Work Order ID 92951

Item Name: Crosstube Aft

DRAWING NO. D412-664-243	TITLE CROSSTUBE ASSEMBLY (412 HI AFT)	REV. E	DART AEROSPACE LTD ENGINEERING ORDER		D.E.O. NO. D412-664-243-E-1	SHEET NO. SHEET 1 OF 2	SCALE NTS
DRAWN	CHECKED	MFG. APPR.	APPROVED	DE APPR.			
DATE 11.03.31	DATE 11/03/31	DATE 11.03.31	DATE 11/03/31	DATE 11-03-31

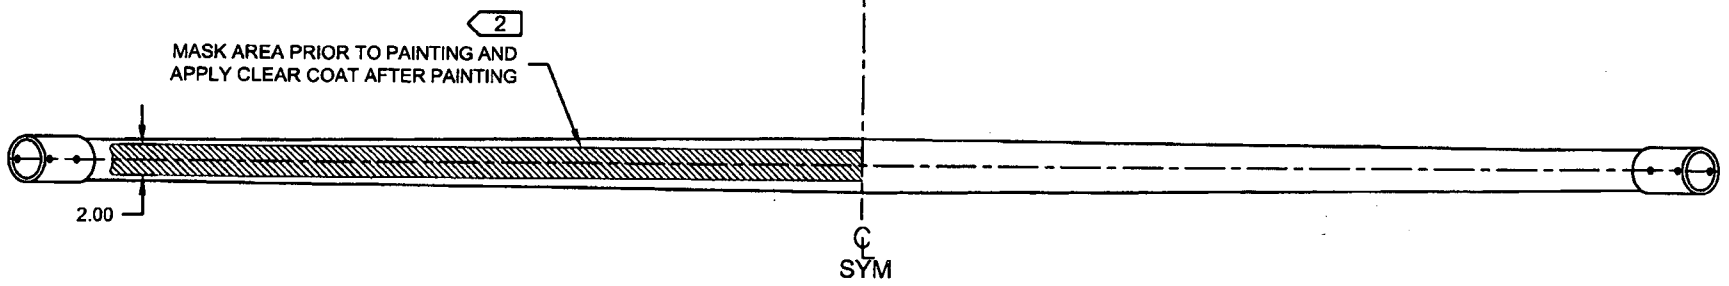
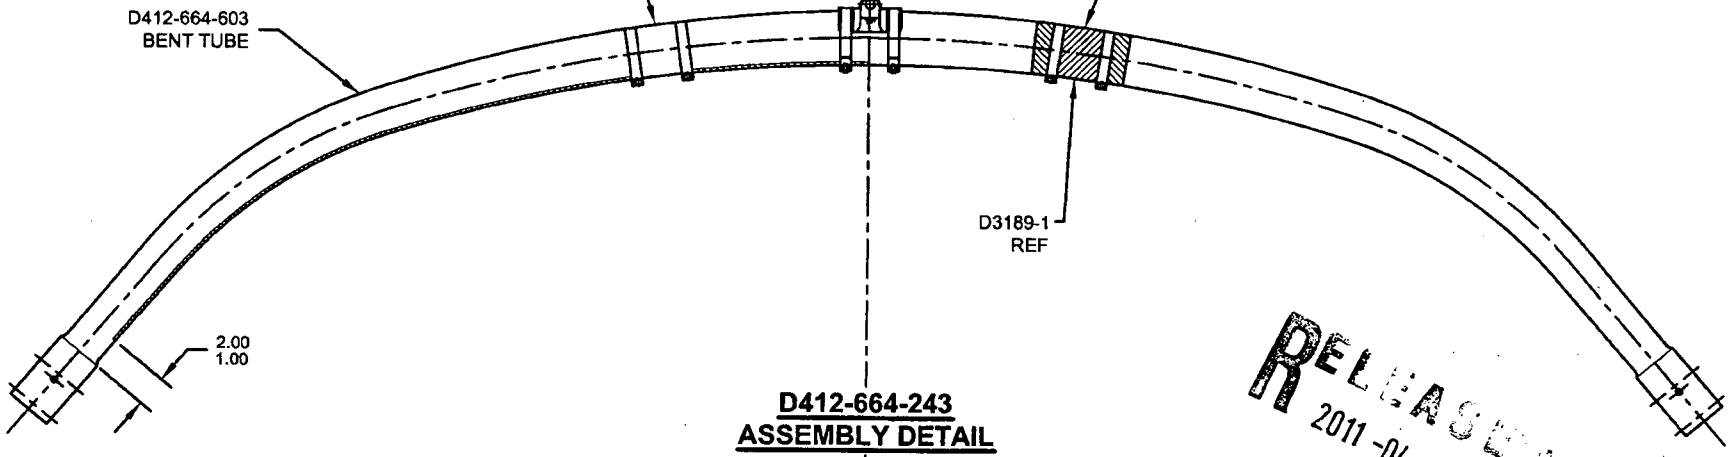
NOTES 2 AND 14, SHEET 1 ARE AMENDED AS FOLLOWS:

WAS:

D2856-600-1009 ABRASION STRIP
D3189-1 CHAFING SHIELD (1, INSTALLED OVER ABRASION STRIP)
MS21920-28 CLAMP, 2X
2 PL

D3189-1 CHAFING SHIELD (1, INSTALLED OVER PROSEAL 890)
MS21920-28 CLAMP, 2X
2 PL

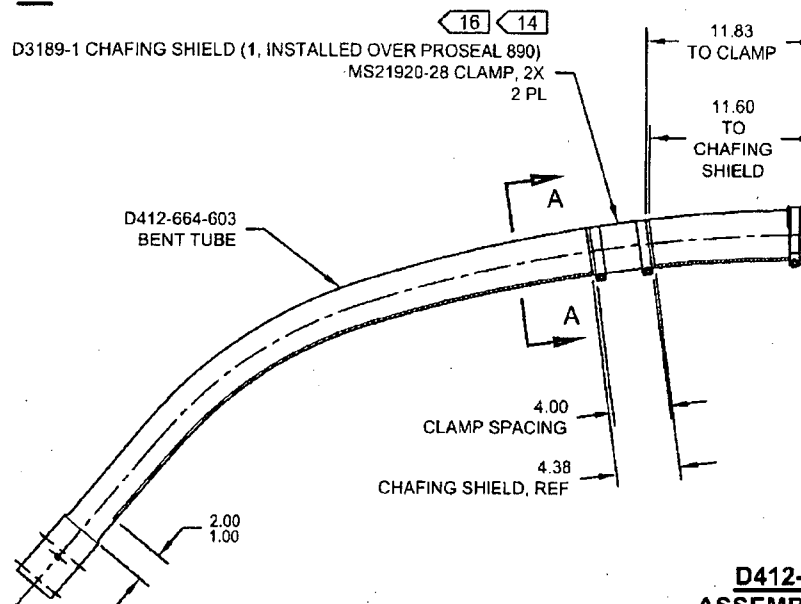
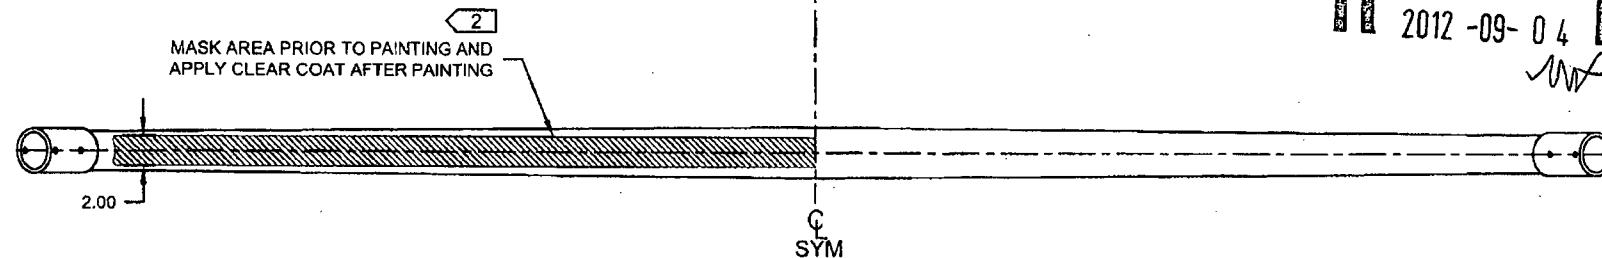
WAS:

D2856-600-1009 ABRASION STRIP
D3189-1 CHAFING SHIELD (1, INSTALLED OVER ABRASION STRIP)
MS21920-28 CLAMP, 2X
2 PL

IS:

D3189-1 CHAFING SHIELD (1, INSTALLED OVER PROSEAL 890)
MS21920-28 CLAMP, 2X
2 PL

SECTION A-A
CHAFING SHIELD DETAIL
VIEW ROTATED, NOT TO SCALE

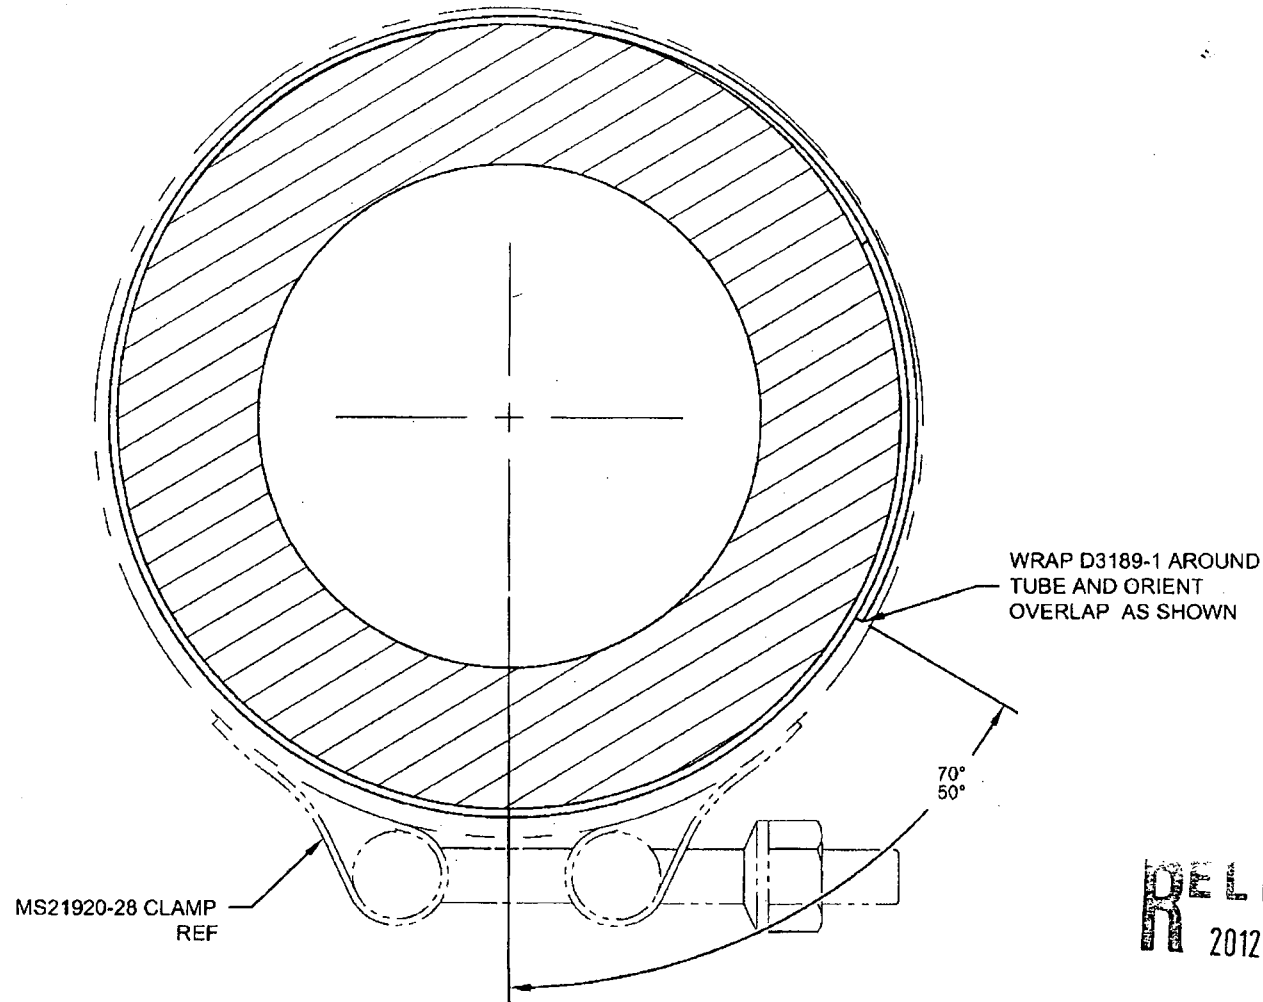
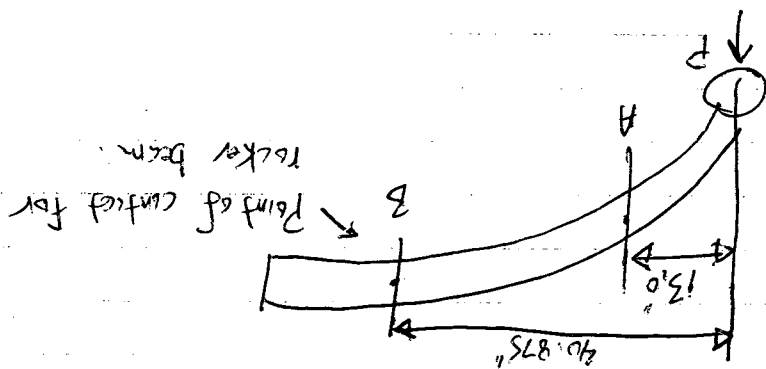
MASK AREA PRIOR TO PAINTING AND
APPLY CLEAR COAT AFTER PAINTING
